May 16, 2006 CPC

STAFF'S
REQUEST ANALYSIS
AND
RECOMMENDATION

06TS0337

LBV Investments, LLC
(St. Ives)

Exhibit B

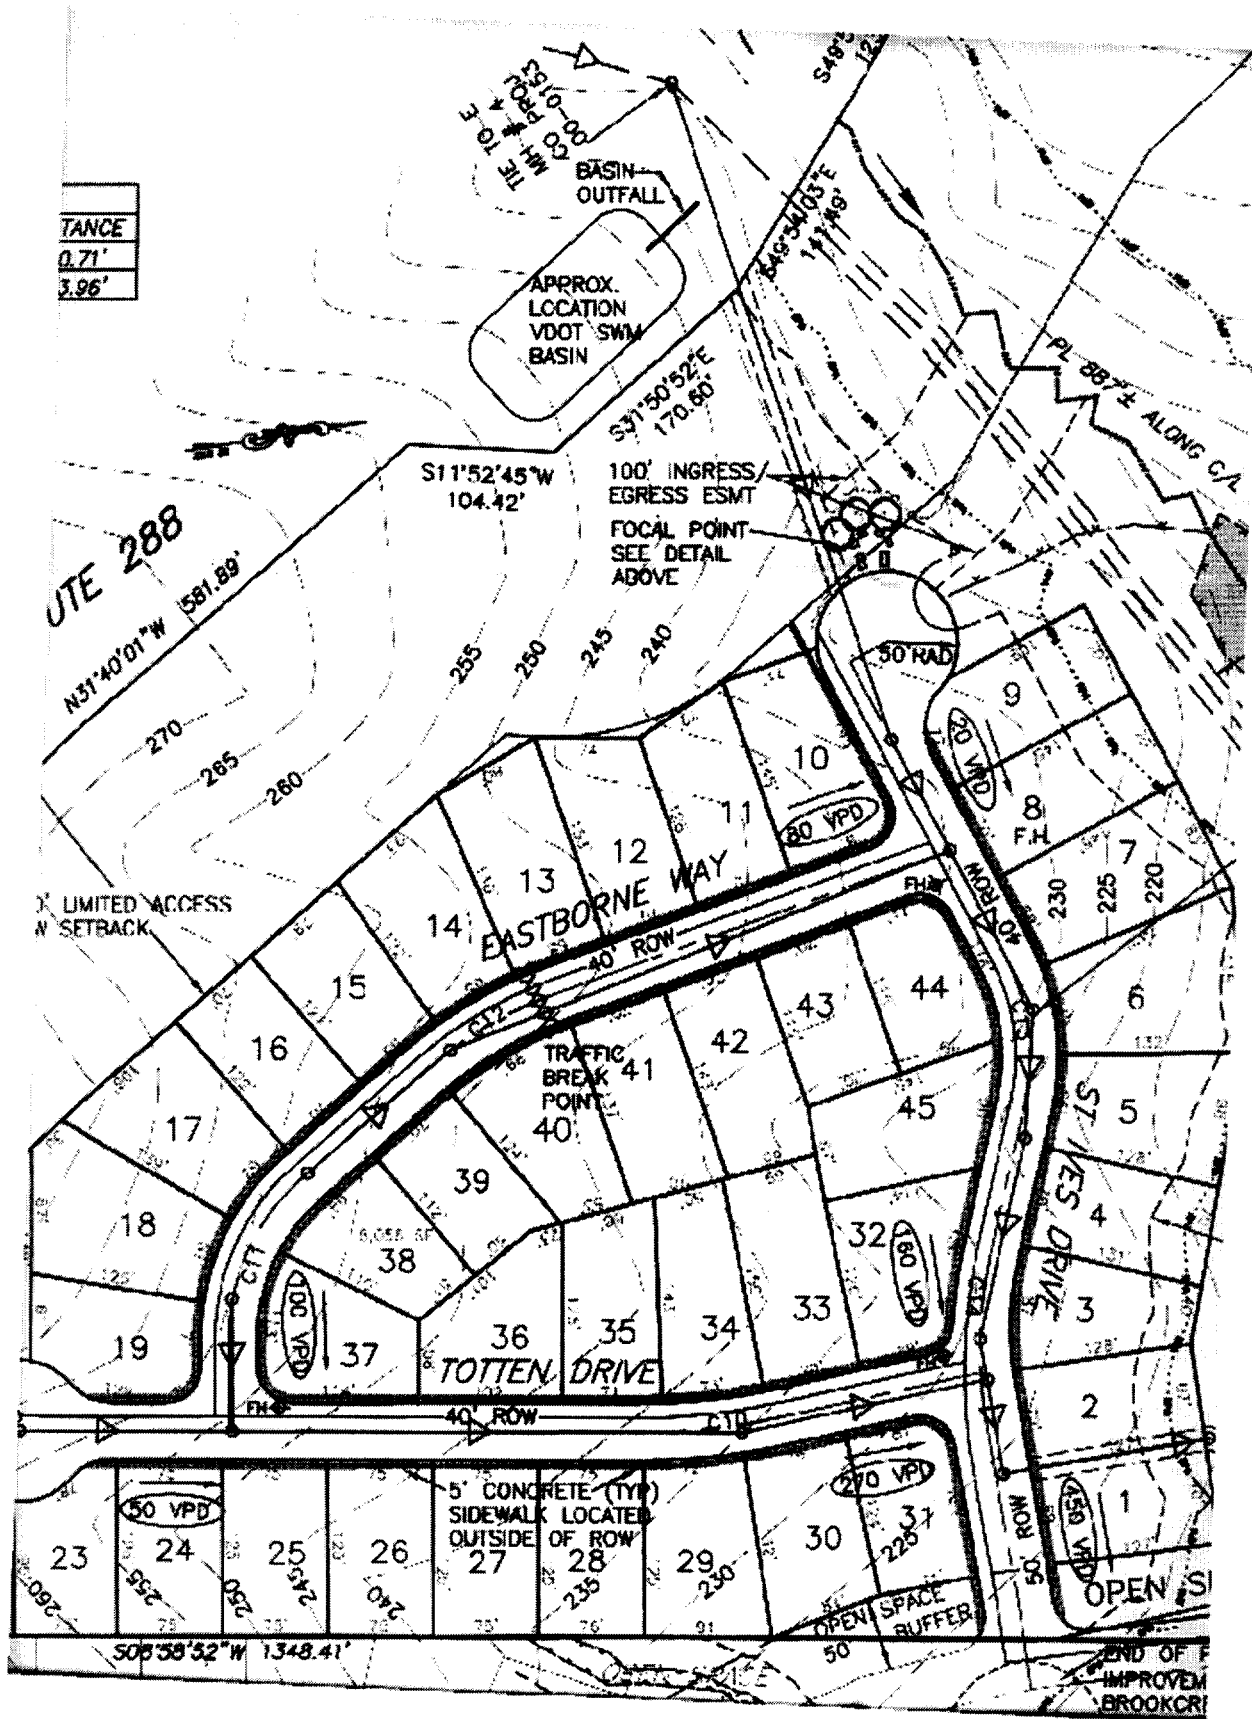
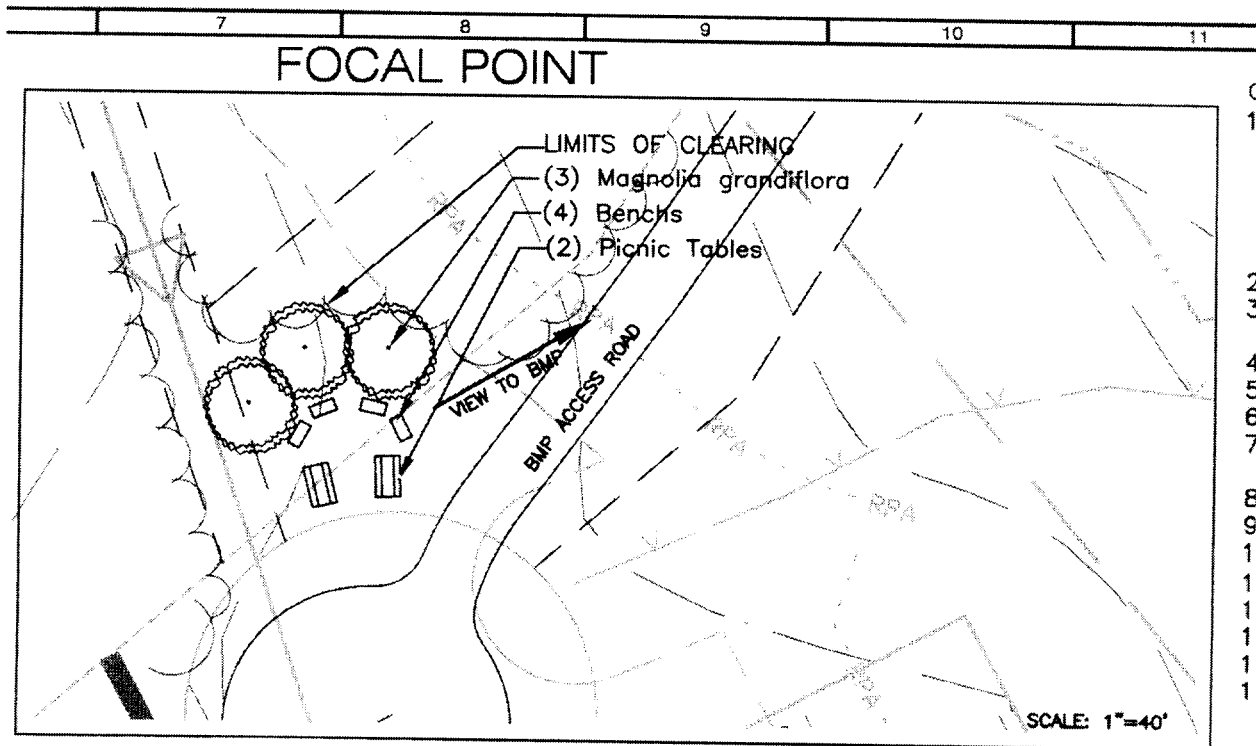
The applicant provided a conceptual plan showing the location and contents of the focal point. (See Exhibit B), but failed to illustrate the exact limits of the clearing required to install the focal point. Staff noted that the plan did not adequately address the limits of the clearing in the 200 foot sound setback and requested additional information from the applicant. As of the date of this report that information was not yet available.

- a. Label the buffers along North Otterdale Road as open space per Proffered Condition 2. (P)
- b. Provide documentation showing the exact limits of clearing. (P)

- g. Show the boundaries that meet the .75 acres required. (P)
- h. Show the limits of clearing. (P)
- i. With respect to road names, St. Ives Way is a road name duplication with the St. Ives Drive. Road name duplications are only permitted when a cul-de-sac comes off of a road of the same name. (EE)
